Appl. No.: 10/711,100
Amdt. Dated: 7/9/2007
Reply to Office action of: 04/30/2007

REMARKS/ARGUMENTS

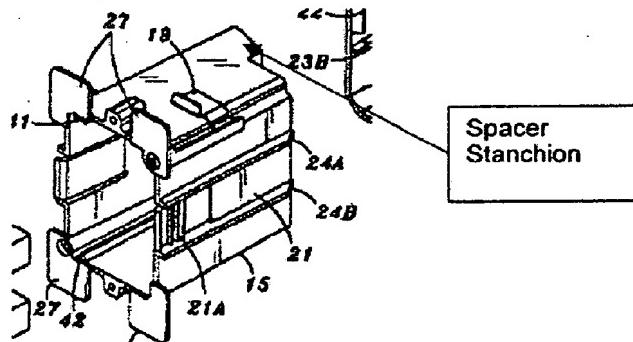
The patent to Berges discloses a device having a bin (21) having one closed end and open end and further having a top wall with a structural rib (24a), a bottom wall and two side walls having a mounting tab (27) located thereon, the tab having a bore therein, the rear end having a spacer stanchions (See Below) located thereon, the bin having an exterior dimension allowing mounting within an instrument panel opening designed for a larger than standard sized radio and further having interior dimension allowing mounting of a standard sized radio directly therein.

The patent to Berges et al. does not disclose a pair of spacer stanchions on the rear wall.

Applicant respectfully traverses this rejection. The key to Applicants' invention is a bin that allows for the mounting of a small footprint radio within an instrument panel large footprint radio-mounting bin without out the need for providing two separate instrument panels on the assembly line. Furthermore, the claimed invention is configured such that it is simply inserted into the much larger opening and fixed to said instrument panel thereby providing the proper mounting opening size such that the radio mounted therein does not require butterfly bending and expandable mounting appendages or other special fittings.

A fair reading of the Berges et al. (US 6,533,225) reference discloses a control housing (15) for wall mounting audio controls used in home electronics (see for example, Col. 1, lines 15 – 29). The control housing (15) may be mounted directly to the drywall wall substrate (see for example, Col. 3, lines 53 – 59) or it may be mounted within a second housing (13) mounted to a wall stud (see for example, Col. 3, lines 15 – 17). This second housing (13) is open backed comprising only two side walls and a top and bottom (see for example, Col 4, lines 17 – 26, and Figs. 4A – 4D). Thus, the Berges et al. reference teaches a combination of mateable housings; one suitable for new construction installations, and the other independently suitable for retrofit installations (see for example, Col. 4, lines 1 – 4). The control housing (15) is mounted flush to the outer surface of the drywall using four stop flanges and at least one retractable backside wall

clamp when it is mounted by itself (see for example, Col. 3, lines 55 – 64). When mounted within the second housing (13) it is positioned flush to the dry wall outer surface by the four stop flanges and mounted to the second housing (13) using ridges on flexible fingers engaging with clamps in said second housing (13) (see for example, Col. 4, lines 27 – 42). This reference does not disclose, teach, or fairly suggest any stanchions at all. What the Examiner has determined to be a stanchion is in fact specifically taught by the reference to be the opening portion of the rear of the control housing (15) to allow passage of connection wiring through the control housing (15) back to the audio control mounted within (see for example, Col. 4, lines 42 – 46, and Fig. 5D). This reference specifically teaches that the control housing (15) is positioned by the stop flanges on the front of the control housing (15) not anything on the rear of the housing. Likewise, the second housing (13) does not have a back at all and is positioned by mounting against the side of a wall stud using one or more nails or screws. Said control housing (15) is positioned within this second housing (13) by the stop flanges butting up against the outer surface of the drywall just as in the installation without said second housing. Thus, like other electrical systems mounted in building walls the mounted devices are not positioned by butting against the inner surface of the outer wall by means of stanchions.

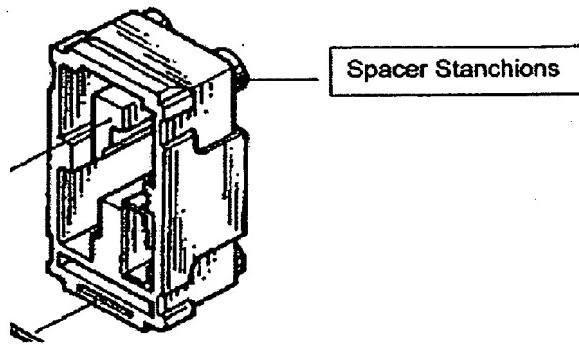
The patent to Tsai teaches a mounting device having a closed rear wall which has a pair of spacer stanchions thereon, the pair used as a design choice to space the rear wall from the desired device.

Therefore it would have been obvious to one of ordinary skill in the art to have used a pair of spacer stanchions in order to have the rear wall spaced as desired by a design choice.

A fair reading of the Tsai (US 5,452,175) reference discloses a mounting plate (20) for mounting at least a pair of electrical outlets and/or switches (30 and 40 respectively) therein (see for example, Col. 2, line 25 – Col. 3, line 4). The reference further teaches the use of electrical buses mounted in said mounting plate (20) for easy electrical connection of the outlets (30) and switches (40) (see for example, Col. 2, lines 42 – 45). However, these outlets (30) and switches (40) are all of the same standard size and therefore no means of mounting different sized objects within the mounting plate (20) is disclosed, taught, or fairly suggested. Here the Examiner has lifted the housing of a switch (40) from Fig. 3 and determined that the wire connection ports (similar to those shown in the prior art switches 13 and 14, namely wire connection areas containing wire connection ports 131 and 141) are stanchions. However, since electrical outlets and switches mounted in building walls are surface mounted to the wall they are exposed through and not to the wall behind, or on the back end of the studding, stanchions on the rear of the electrical outlets (30) and switches (40) are not only not disclosed, taught, or

fairly suggested, those skilled in this art would not contemplate them because they are of no use to these devices and their installation.
